# ARVIN RADIO

ARVIN RADIOS, MODELS 480TFM AND 481TFM  
CHASSIS RE-277 & RE-277-1, 8 TUBE AC, AM-FM

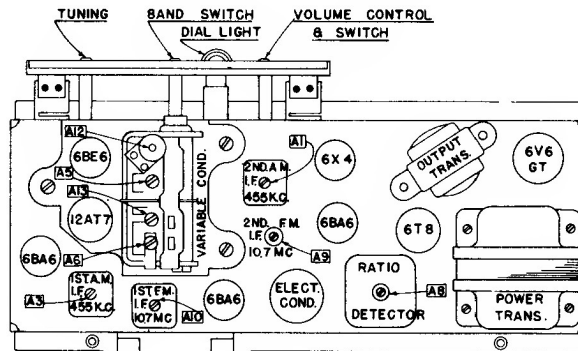
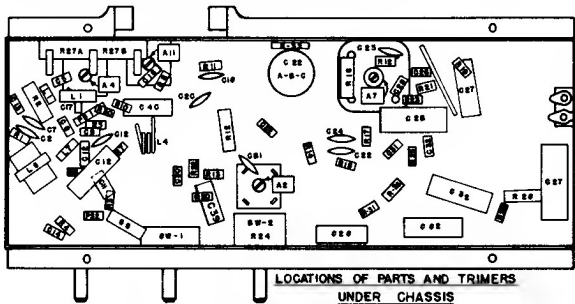
The Schematic Diagram printed in this bulletin is for Chassis RE-277-1 which includes a bass boost & hum reduction circuit. Chassis RE-277 differs from Chassis RE-277-1 in the following respects.

1. C38 was .02 uf. 400 V., and was connected from plate to screen of the 6V6GT tube.
2. R31, 150 K ohm 1/4 watt Resistor, was not included in the circuit and R26 connected directly to B+ 140 V.
3. R32, 120 ohm 1 watt resistor, was not included in the circuit and C35B electrolytic condenser section connected to the center tap of R27.
